MEMORANDUM

TO	Emma McGivern	COMPANY	Rio Tinto
FROM	Andrew Chapman	OFFICE	Brisbane
EMAIL	andrewc@atcw.com.au	PHONE	0407 640 494
PROJECT TITLE	Winu Copper Gold Project		
SUBJECT	Peer review of the mine site and access road SWMPs and TUFLOW models		
DATE	9 May 2025	OUR REF	250640M001-Rev2

DIAGRAM 1. POTENTIAL UPSTREAM CATCHMENT NOT BEEN INCLUDED IN TUFLOW

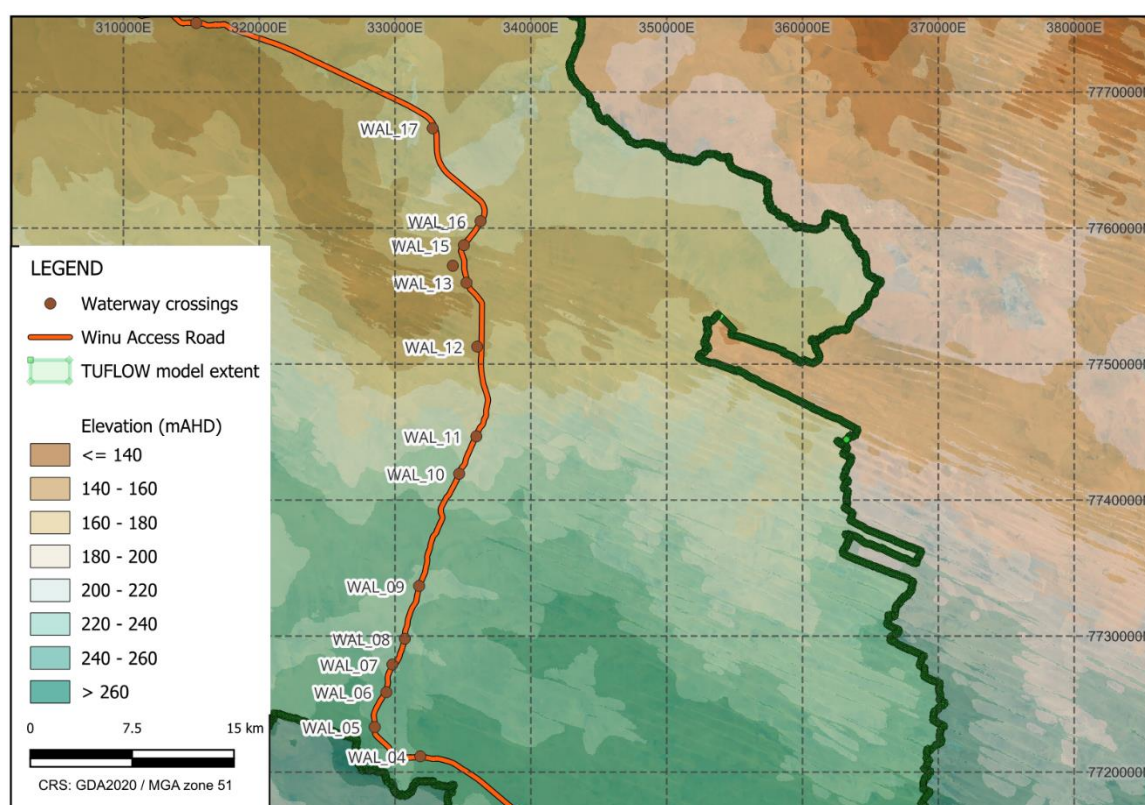
However, there appears to be an upstream catchment that has not been fully captured in the model domain (shown in **DIAGRAM 1**). This catchment is located to the east of the current model extent and may contribute to flow accumulation at the WAL_15 and WAL_13 access road crossing locations. This should be considered further.

1. Extend the model domain to include the potential catchment to the east of the TUFLOW model domain presented in DIAGRAM 1.
2. Review the current simulation end time and determine if additional modelling time is necessary to capture the entire flood progression.
3. Update the peak depths in Table 5-3 to match the peak depths in the supplied TUFLOW result rasters.

Access Road SWMP	
Extend the model domain to include the potential catchment to the east of the TUFLOW model domain presented in DIAGRAM 1.	The catchment area east of this area was assessed early on in this project and is internally draining, not reaching the road in the 1% AEP storm so it was clipped from the model to improve runtimes. The top catchments were included to cover the existing road.
Review the current simulation end time and determine if additional modelling time is necessary to capture the entire flood progression.	There was one crossing (WC17) with a maximum depth at 20 hours at the end of the 1% AEP simulation. The model was re-run for 30 hours and there was no increase in ponding depth. The other events were also re-run with longer simulation times and found to have no increase in maximum depths.
Update the peak depths in Table 5-3 to match the peak depths in the supplied TUFLOW result rasters.	The depth calculations have been revised over the whole region which increased some of the maximum depths marginally. Evaporation (9 mm/day as per the Telfer Aero loggers) has also been included in the inundation calculations for consistency with the Mine SWMP, which made a minor reduction in inundation times.
